Subject: Docket No. 2018-0165 – Integrated Grid Planning
Instituting a Proceeding to Investigate Integrated Grid Planning
Grid Services and Planning Criteria Feedback

Instituting a Proceeding to Investigate Integrated Grid Planning (“IGP”)
Hawaiian Electric Stakeholder Meeting to Address Order No. 37730 and
Ulupono’s Comments on Modeling Approaches

3. Model Selection and Process Flow Chart

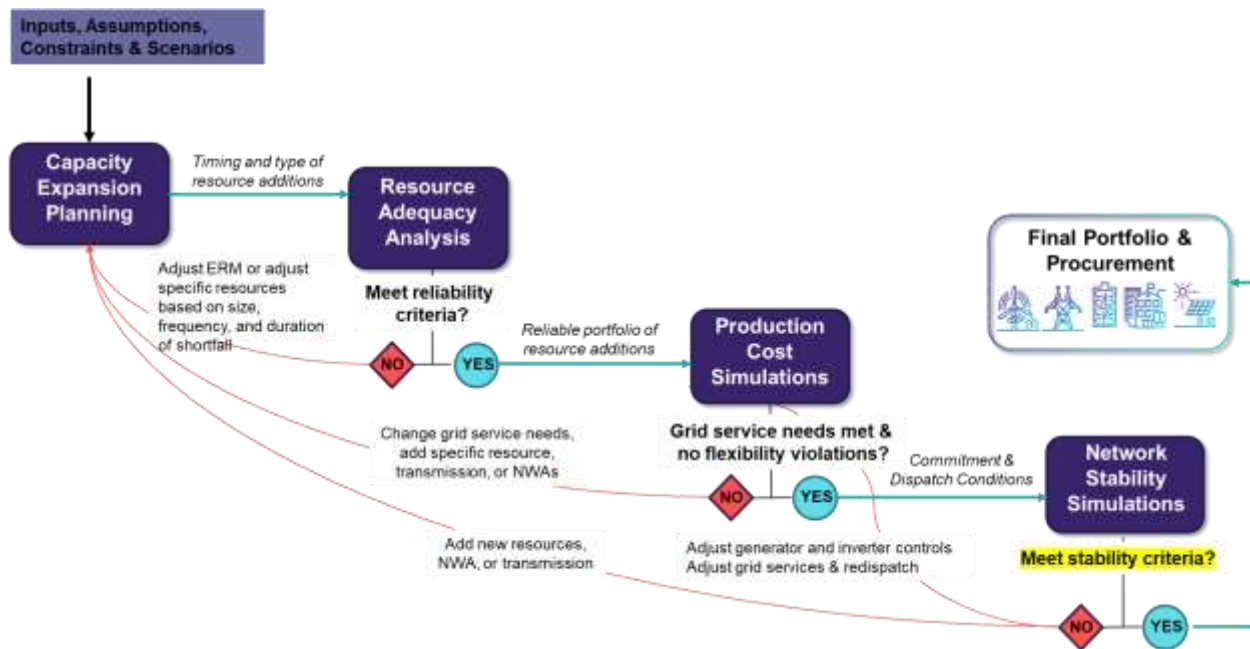
The TAP agreed with the process flow summarized in the above figure. TAP also provided some additional detail in response to HECO questions and/or TAP commentary. These are summarized in the following bullets:

- The TAP initiated a discussion on the use of RESOLVE vs PLEXOS as the screening tool. All parties agreed that both PLEXOS and RESOLVE can be used for capacity expansion, but HECO stated that the ability for RESOLVE to run faster than PLEXOS is a significant advantage given the number of runs that are likely to be required. There was no objection to this position by the Company. However, consistent with the diagram above, it was again noted that RESOLVE provides limited fidelity and should be used only as a technology screening tool. Subsequent determination of reliability, analysis of multi-year weather data, retirements, and avoided costs, etc. requires the use of other modeling tools. It was emphasized more than once that the other models should be an integral part of the overall process, NOT just a check on the output from RESOLVE.

- During the May 25 meeting, HECO sought TAP guidance from TAP that essentially asked “What is the tolerance used to know when to go back and iterate” and “Is it necessary to always rerun the full process or can estimations serve. TAP did not provide a hard and fast answer to these questions, noting the need for ‘engineering judgement’ and ‘experience’ to determine what needs to be done. While TAP recognizes that engineering judgement can reduce the requirement for the full process to be used for all iterations, TAP recommends that solutions be vetted by the full process before proceeding to the procurement phase.

- The TAP also initiated a discussion that suggested the possibility of putting LOLP in as a hard constraint during the capacity expansion modeling effort. It was noted that some utilities define their resource adequacy needs first, using clearly specified LOLP metrics for every day of the year to develop a reserve margin. Hawaiian Electric uses a 1 day in 4.5 year LOLP planning metric for Oahu. This reserve margin then goes to the capacity expansion model, which solves to meet the required reserve margin. After some discussion, it was generally agreed that this approach may be more appropriate for systems that are less distributed, and less reliant on renewables with short-term battery energy storage than the Hawaii systems, and which experience relatively minor year to year changes because of different resources or outages showing up on different resources in different years. There is additional discussion of the use of ERM with RESOLVE in Section 6, below.

- The question was raised as to whether the proposed Process Flow was adequately accounting for the growth and value of DER. DER growth is not an explicit output of any of the models. TAP conveyed that while not an output, carefully selected scenarios, such as different assumptions about DER, would allow evaluation of the cost/benefit of these technologies. It was again noted that to properly assess and incorporate DER would require use of the Process Flow, not just RESOLVE to ensure that viable, reliable scenarios were being compared. This discussion was broadened some with TAP recommending that before running different scenarios, HECO clearly define the objective of those comparative scenarios before running the models and fully define the process to be used for those comparisons.

- The question was raised in regard to “What cases would be evaluated in network stability? Is it day min/max and evening min/max or others?” The related question was that if inertia and FFR are modeled in both RESOLVE/PLEXOS and a stability tool such as PSSE/PSCAD, which would take priority? HECO stated that they would give priority to PSSE/PSCAD, but if they found the RESOLVE/PLEXOS is adequate, then there may be no changes. The determination of what cases would be evaluated for network stability was less clear. TAP stated that it was important to put cases in context such as with duration curves and believes this question requires more effort.
